Melbourne Hill Road Catchment - Community Values for Flooding Solution

Manningham City Council Media Statement

Enquiry from Warrandyte Diary, Michelle Pini re. Melbourne Hill Road

The Melbourne Hill Road Catchment Community Representative Panel unanimously rejects the report from BMT WBM entitled:

Title:
**Melbourne Hill Road
 Mitigation Scheme 1**

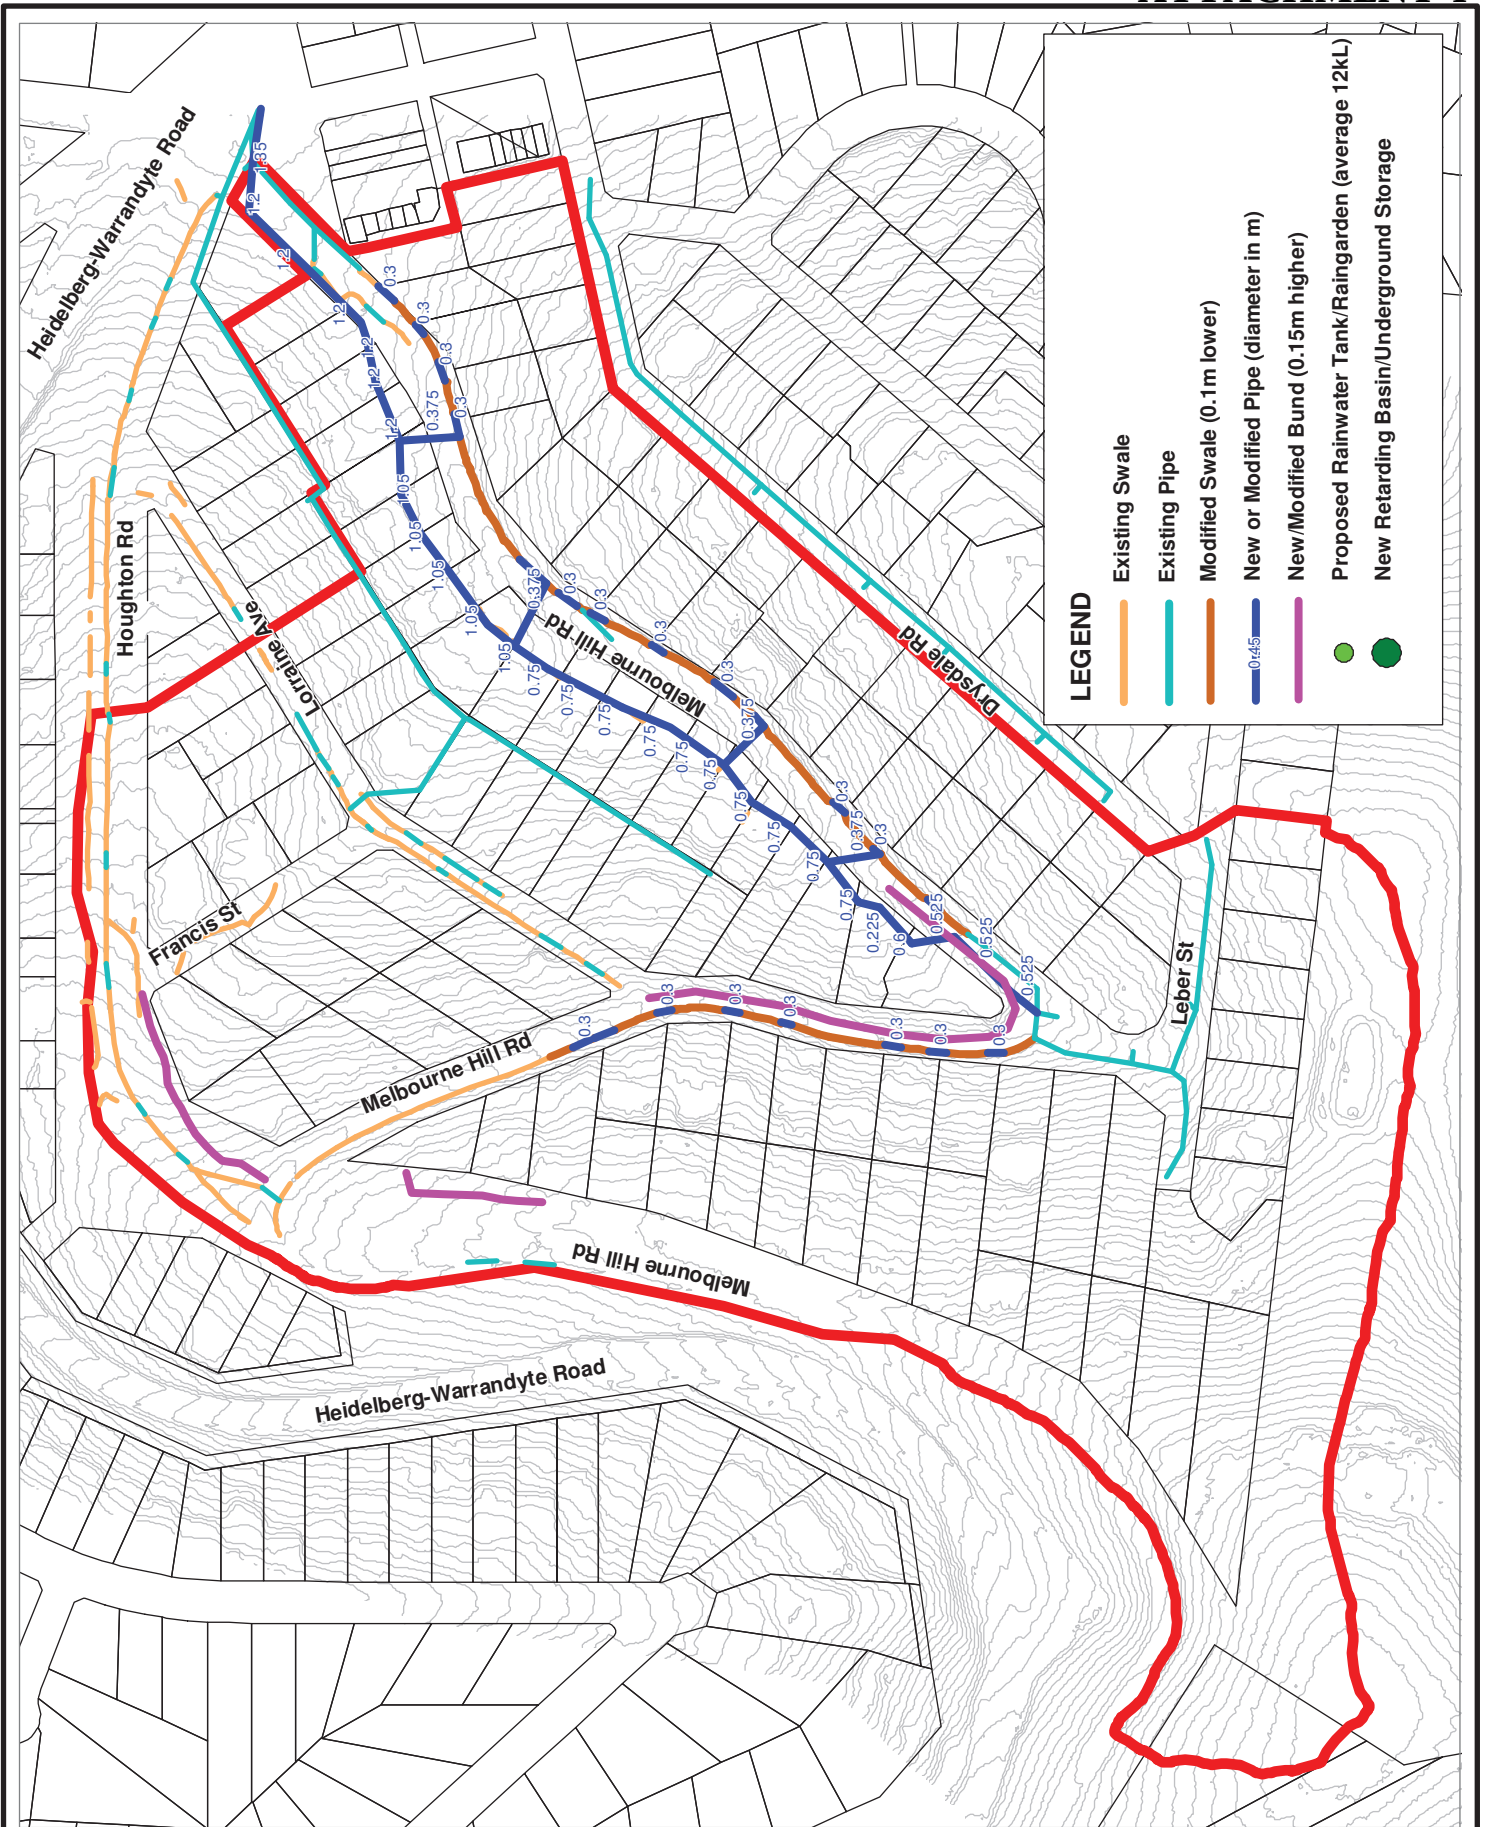
6. The report implies that the Rep Panel endorsed the 4 options modelled, whereas Scheme 1 has never been accepted or endorsed by the Rep Panel

Accepted, however, scheme 1 was required to be included in the Study as part of the agreed Project Brief, in order to have it checked for probity purposes, and to enable the consultant to independently assess it against any other model they may have come up with.

Title:
**Melbourne Hill Road
 Mitigation Scheme 5**

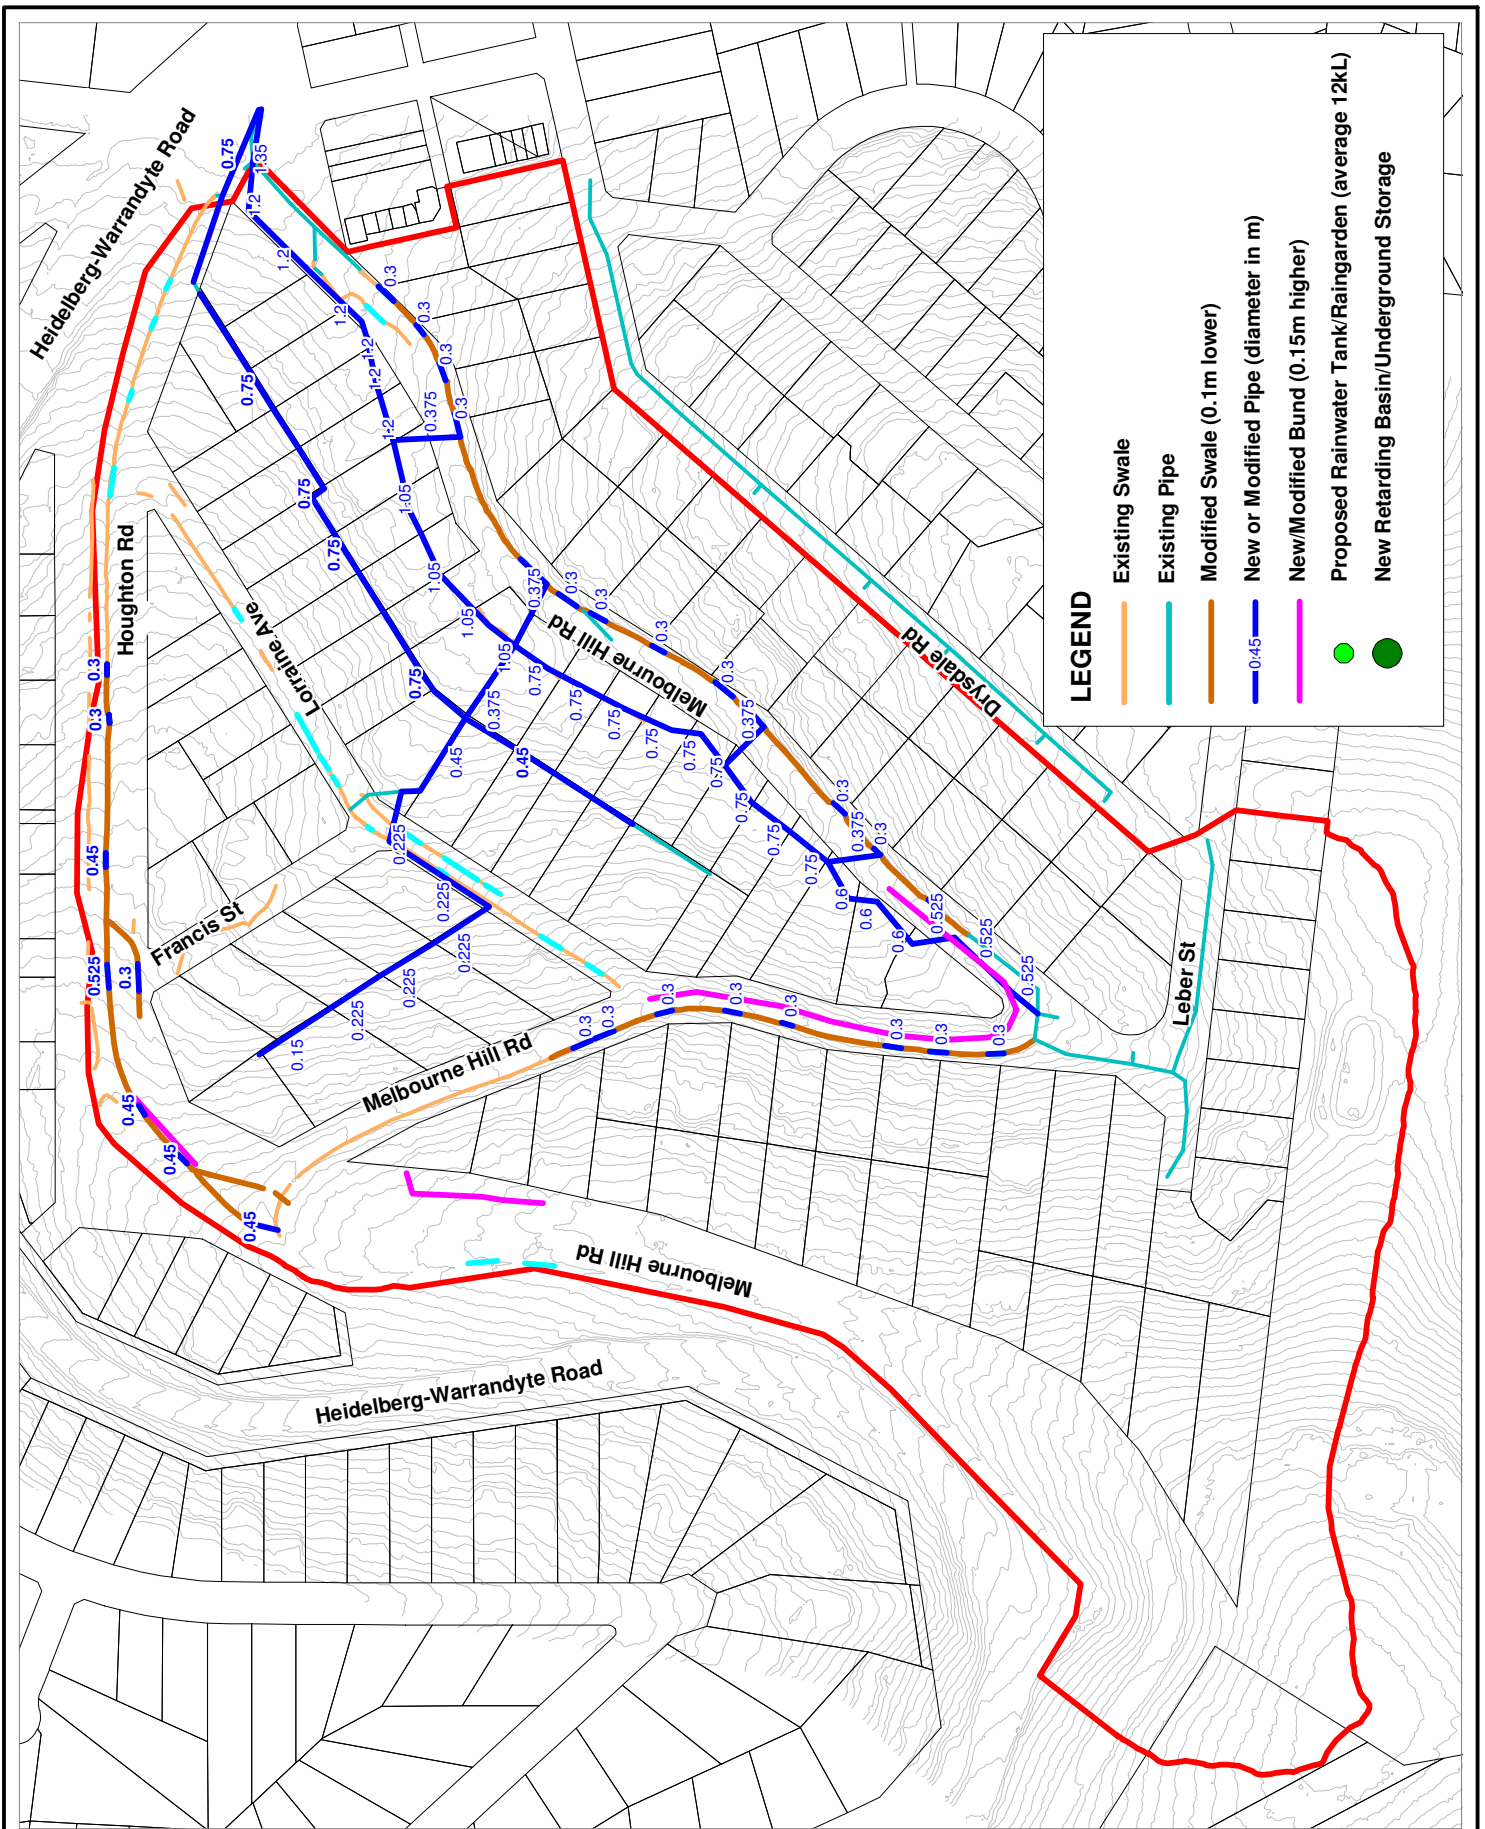
Scheme 5 as modelled was not agreed to by the Rep Panel.

This is not correct. Scheme 5 was proposed by the Reference Panel following the community shortlisting workshop conducted on 30 April 2015, to replace scheme 3 as developed by the community. Scheme 5 was modelled based on the options originally provided by the Panel. After the closing date, the Panel submitted a modified Scheme 5, but the flood modelling had already progressed based on the original Scheme 5. Advice was provided to the Panel that the modified Scheme 5 could therefore not be included in the project.

The diversion of water down Houghton Road is included in scheme 5.

Title:
**Melbourne Hill Road
 Mitigation Scheme 2 (Modified)**

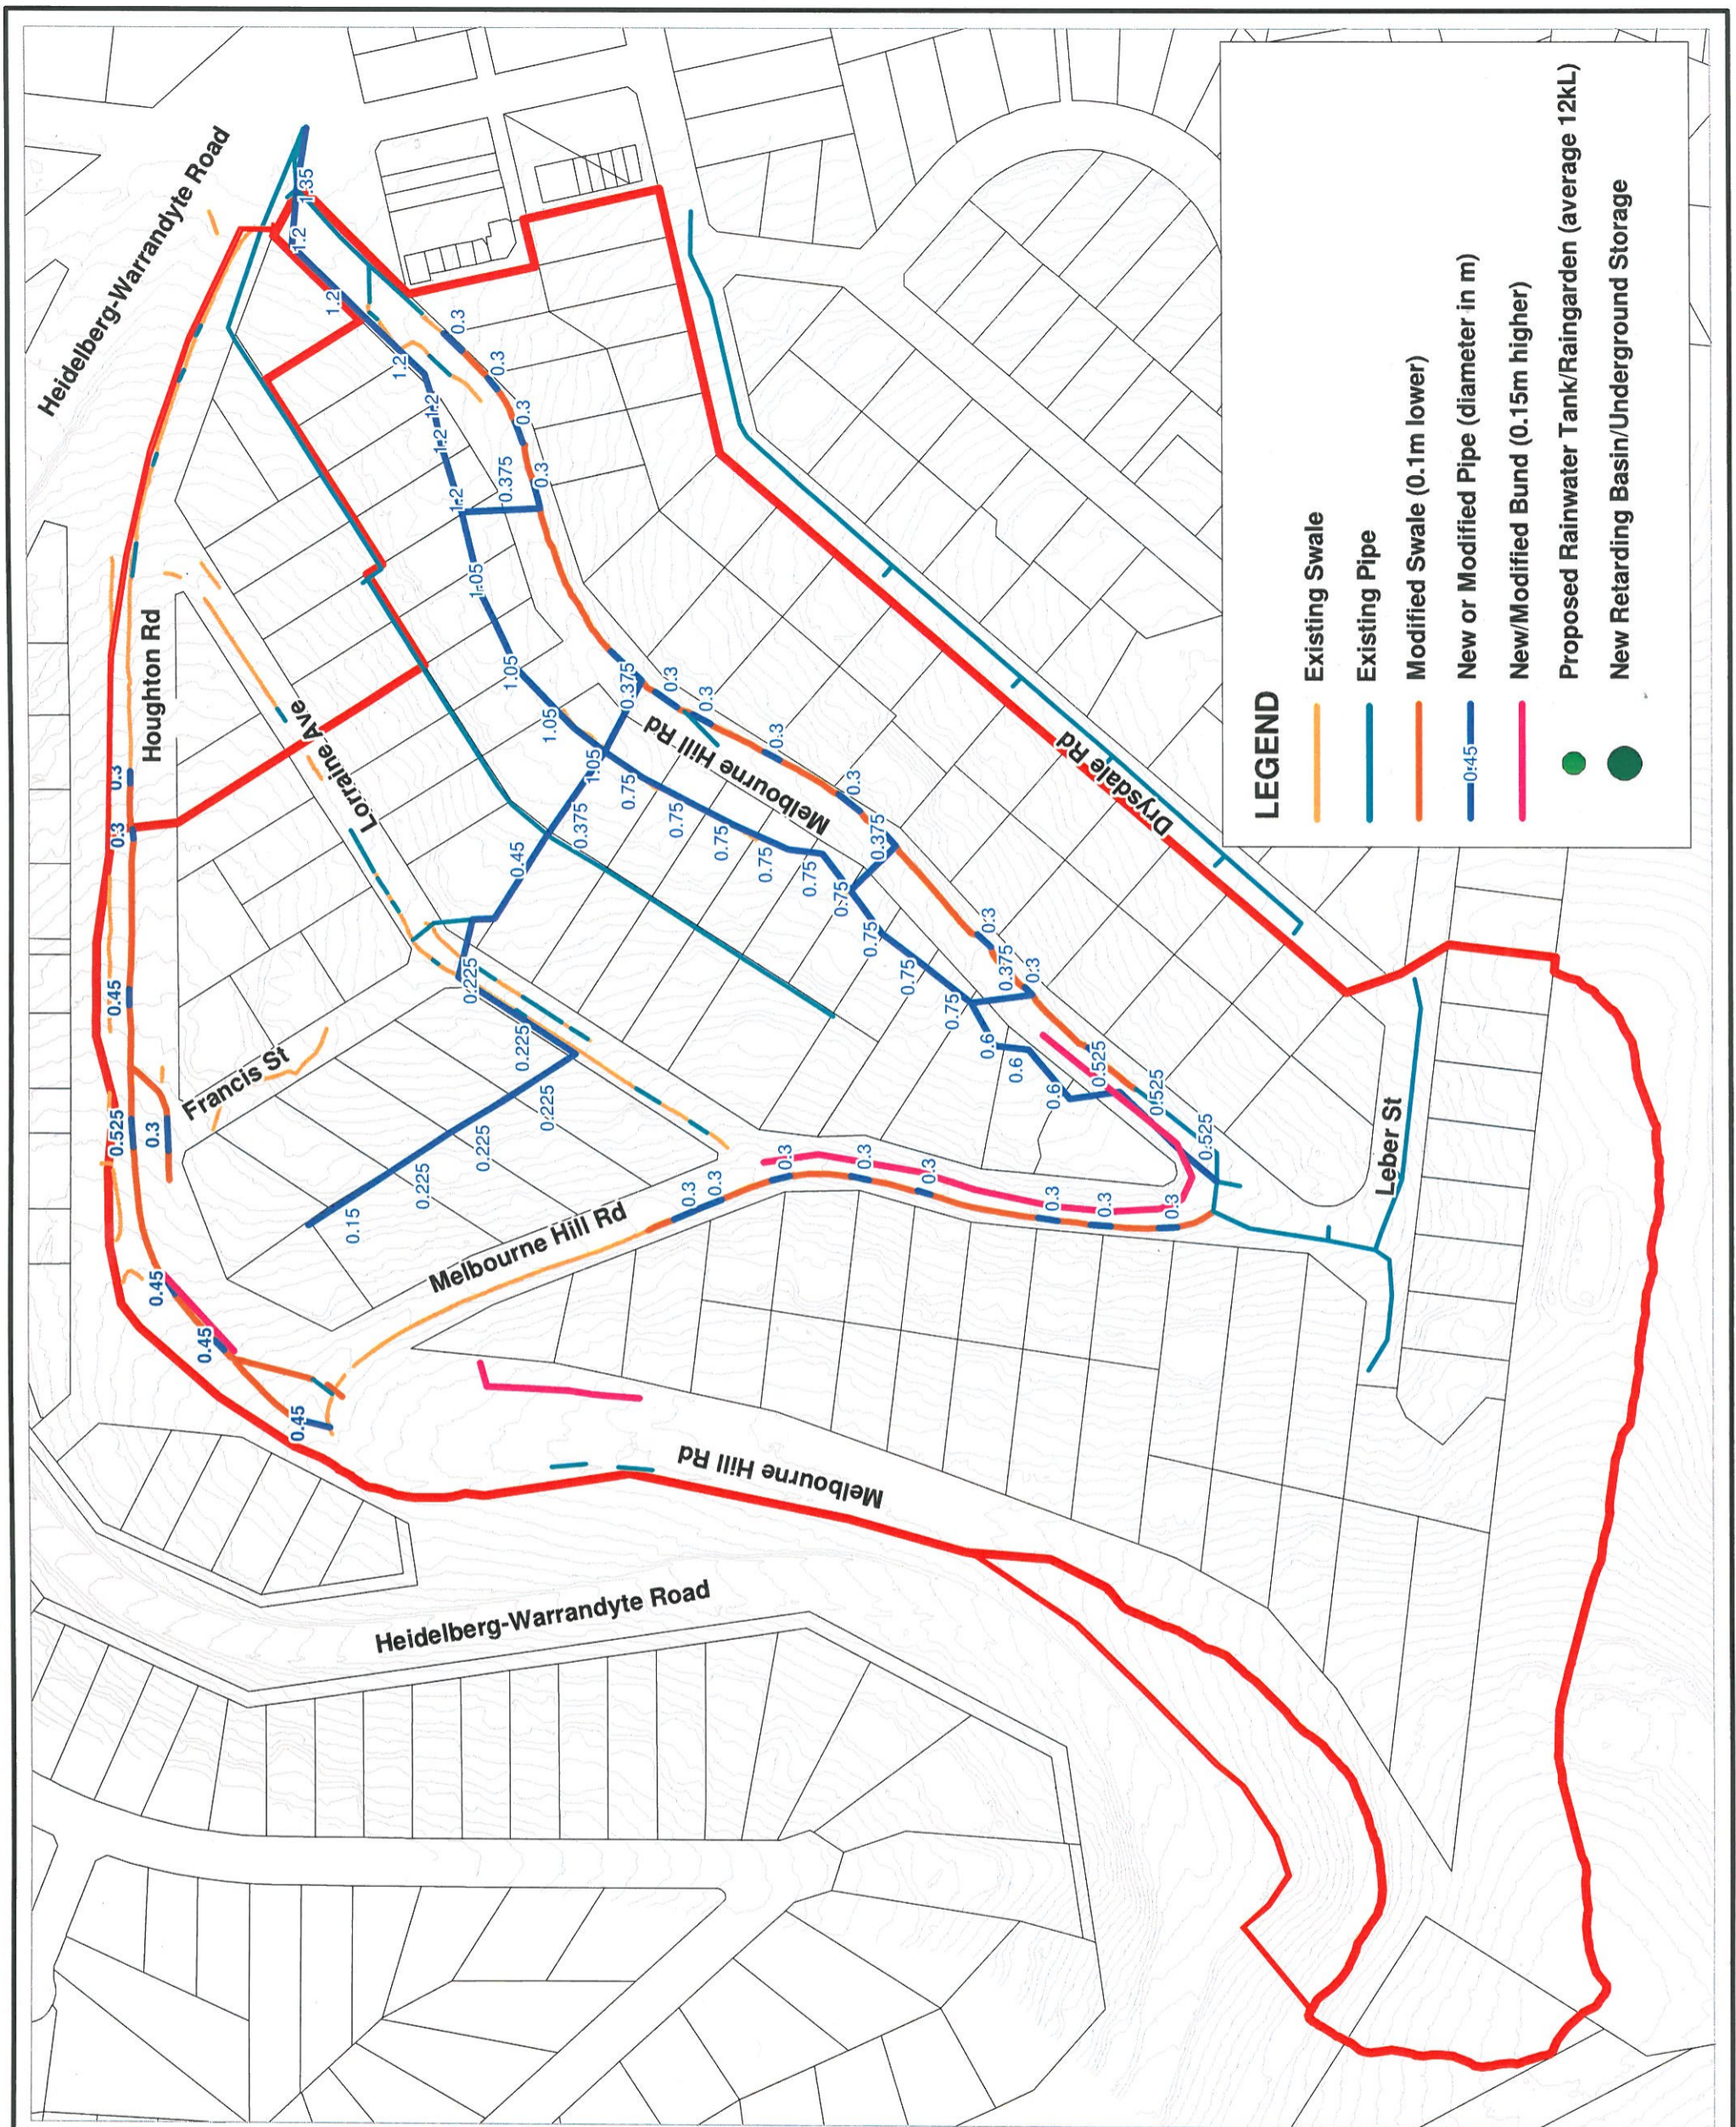
At the August community meeting, residents asked for the least work option (Scheme 2 – no upstream drainage) to be modified and priced to minimise their costs. This modified solution may achieve the flood management outcomes, but may not offer any of the environmental benefits they are seeking and leaves many low side properties without drainage outfalls to accommodate future improvements.

The lowest cost scheme analysed was scheme 2 but this scheme also had the poorest flood mitigation performance. All schemes included similar upgrades to the valley drain. In order to identify a lower cost scheme with comparable flood mitigation performance to scheme 1, it is proposed to work with the Reference Panel to develop a modified version of scheme 2. Scheme 2 (modified) will then be tested through the flood model for the 100 year or major storm event and optimised, and a cost estimate will be prepared. Scheme 2 (modified) will also be assessed against the community and core project values and the results will be shared with the community.

In addition, this lesser cost scheme should not then be used as the basis of resident contributions towards a full drainage scheme (Scheme 1), as, by default, Council would be paying for drains in upstream properties through general rates, rather than the properties paying for what they are liable for. It follows that should a modified Scheme 2 be adopted, further drainage works deemed necessary within this catchment at a later time would attract a special charge.
